ACORN

Issue
2
May 1989

Page	Document Description	SID Ref.
1	News Bulletin	CSN0006
2	Master Series 128 internal MODEM connector	CSN0007
3	Philips Monitor Field Service	CSN0008
9	Appendix	
	Service News-letter November 1988 introduction	
	Archimedes series Field Change Orders overview	
	Archimedes series Field Change Order FCO2002	FCO2002
	Archimedes series Field Change Order FCO2003	FCO2003
	Archimedes series FCO Service Report example

FIELD CHANGE ORDER

FCO 2002 Parallel Printer Port

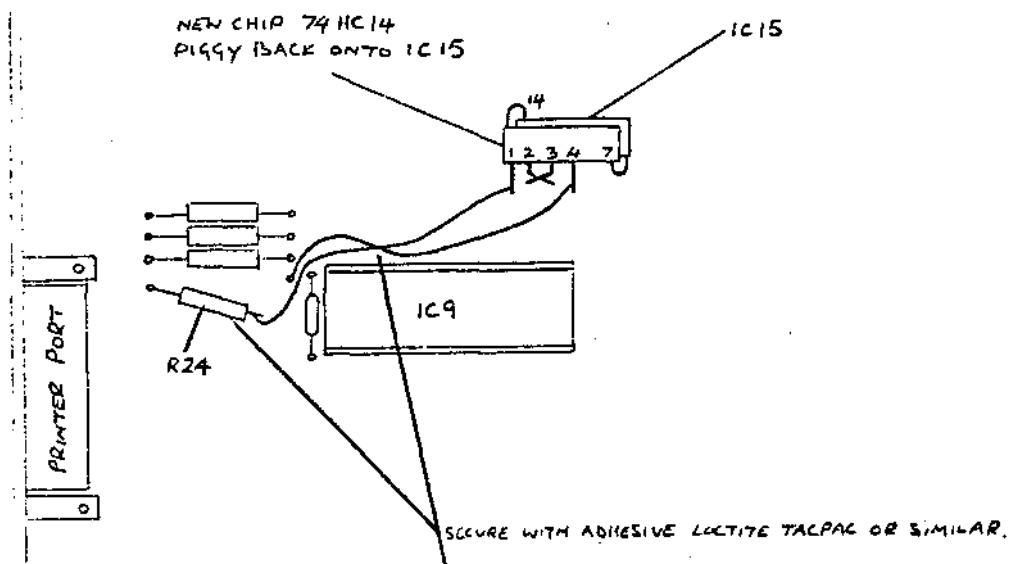
Timing problems with printer control lines have led to spurious operation of some printers. This has proved particularly noticeable when using Integrex colour printers in graphic mode while line feeding - a spurious line feed being generated.

- 1) Remove the circuit board from the computer.
- 2) Refer to diagram 1, and identify R24. Cut the leg of R24 closest to IC9, and carefully move the free end of R24 away from the adjacent resistor. Secure R24 to the PCB with adhesive (for example Loctite TAC PAC), leaving the free end of R24 available for soldering.

- 3) Prepare new IC (74HC14) by:
 - a) Removing pins 5,6,8,9,10,11,12 and 13
 - b) Lift pins 1 and 4 ready to solder leads
 - c) Lift pins 2 and 3, and solder them together

- 4) Position new IC onto IC15 piggyback fashion so that pin 1 of the new IC is directly above pin 1 of IC15. Solder pins 7 and 14 of the new IC to pins 7 and 14 of IC15.

- 5) Solder thin insulated lead from pin 1 of the new IC to the free end of R24. Solder a second insulated lead from pin 4 of the new IC to the vacated pad of R24. Keep these leads as short as possible, and secure them to the new PCB with adhesive.
